ED-HMI3120-116C

PCN

by EDA Technology Co., Ltd

1 Product Change Notice 1

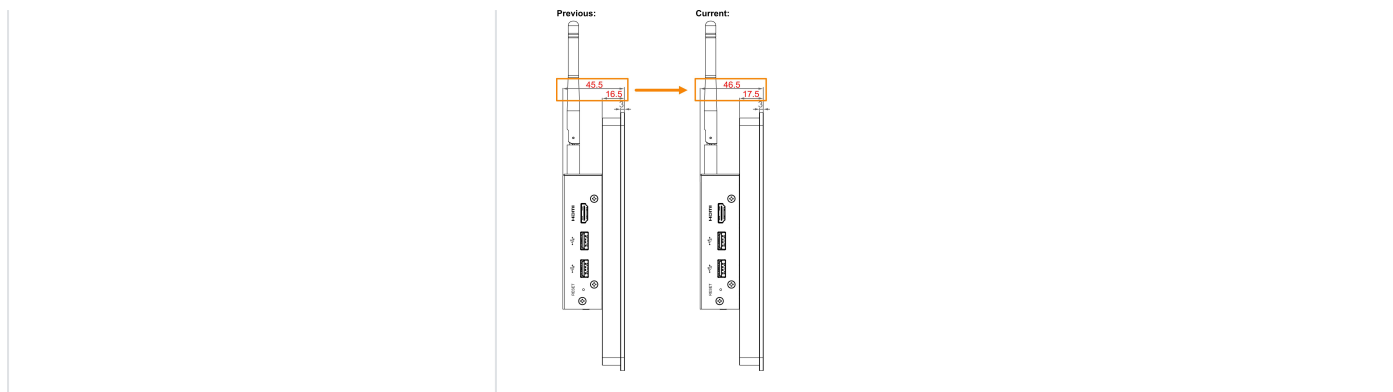
Changes	Results
LCD bezel thickness increased by 1mm	We have optimized the LCD bezel structure to provide additional clearance for internal cable routing. - LCD bezel thickness: adjusted from 16.5mm to 17.5mm. - Total product thickness: correspondingly adjusted from 45.5mm to 46.5mm.
